## Executive Director's Recommendation

Commission Meeting: November 6, 2014

<b>PROJECT</b>	<b>NCPC FILE NUMBER</b>
<b>First Stage Planned Unit Development and Related Map Amendment at Various Lots in Squares 5862, 5865, 5866, and 5867 (A&amp;R Development Corporation, District of Columbia Housing Authority, and Preservation of Affordable Housing, Inc.)</b> Southeast Washington, DC	<b>ZC 14-02</b>
	<b>NCPC MAP FILE NUMBER</b>
	83.00(06.20)43982
	<b>APPLICANT'S REQUEST</b>
	Approval of report to the Zoning Commission of the District of Columbia
<b>SUBMITTED BY</b> Zoning Commission of the District of Columbia	<b>PROPOSED ACTION</b> Approve comments as requested
<b>REVIEW AUTHORITY</b> Approval of Comments to the Zoning Commission of the District of Columbia per 40 U.S.C. § 8724(a) and D.C. Code § 2-1006(a)	<b>ACTION ITEM TYPE</b> Staff Presentation

Figure 10: View from the "Point" on the St. Elizabeths West campus towards the U.S. Capitol (date unknown)

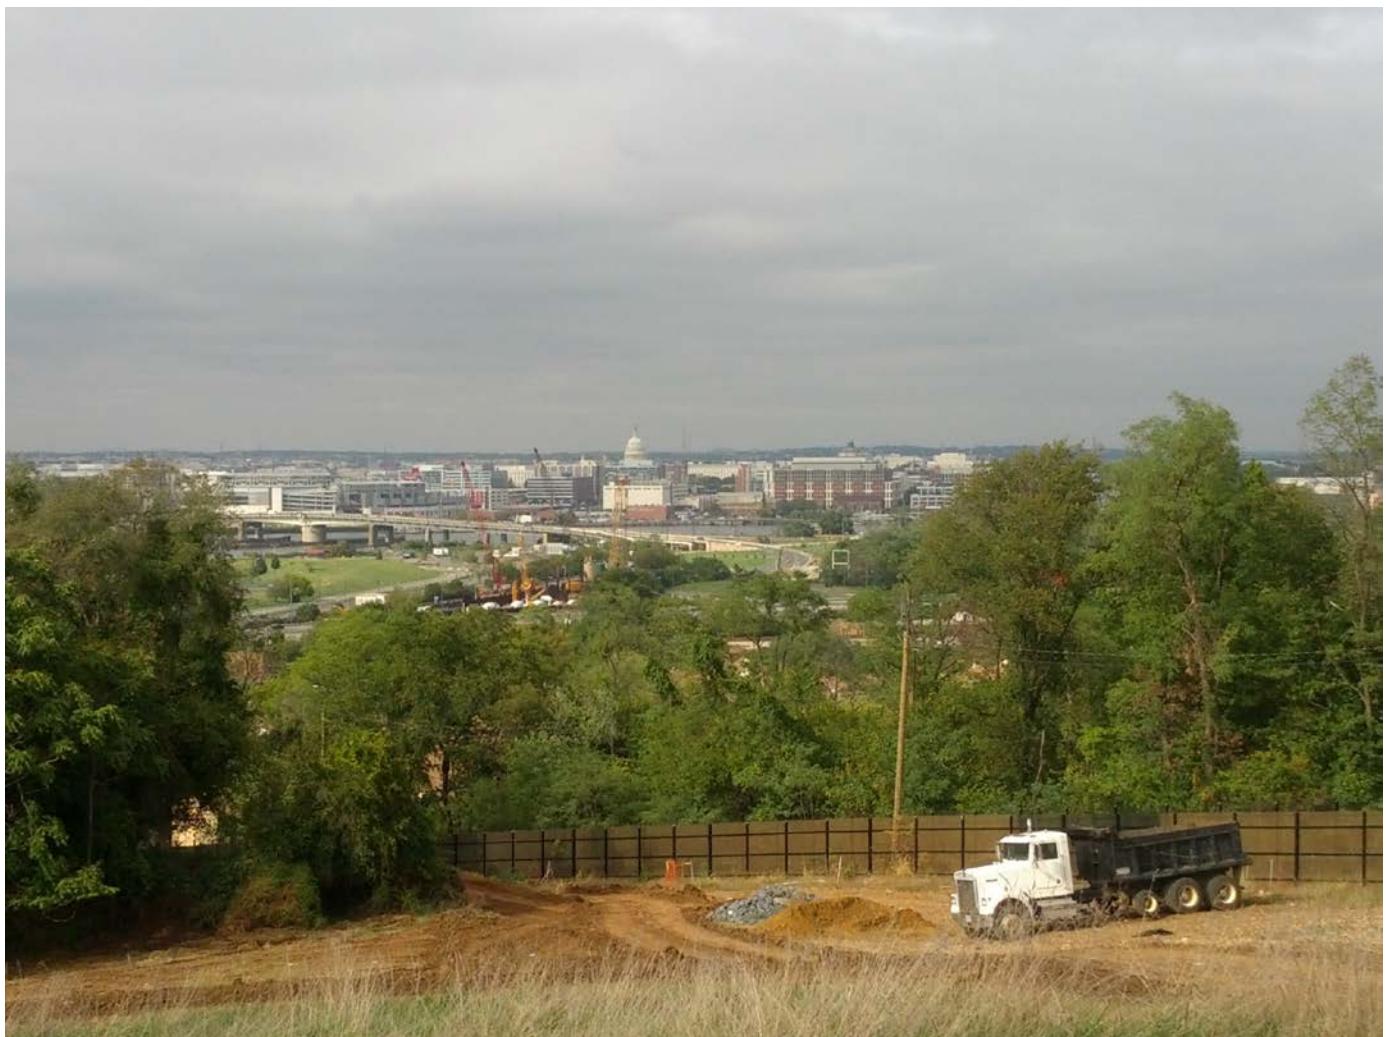
The development team notes through communication with staff that it did consider views from the St. Elizabeths West campus and found that the proposed development would not have any impact on views and vistas given the substantial grade change between the campus and the PUD site. Likewise, staff reviewed the First Stage PUD plans together with typographical maps and has determined that from the First Stage PUD documentation it does not appear that the proposed 65-foot building heights allowed and planned within the proposed C-2-A District at the PUD site will negatively affect the views inward towards the L’Enfant City from vantage points within the St. Elizabeths West campus. Staff will, however, review the Second Stage PUD applications for the site to reconfirm our finding of no negative impact on the historic views between St. Elizabeths west campus and central Washington when the proposed actions to approve the applications are referred to NCPC for comment by the Zoning Commission.

The above photograph shows the view looking north from the "Point" on the St. Elizabeths West campus towards the L'Enfant City and the U.S. Capitol. The fence separates the campus from the PUD site. The trees beyond the fence will remain, and are located within identified green space in the site plan for the proposed PUD. As the topography drops lower beyond the fence, the trees, with seasonal leaves, will screen much of the proposed development from this view. However,
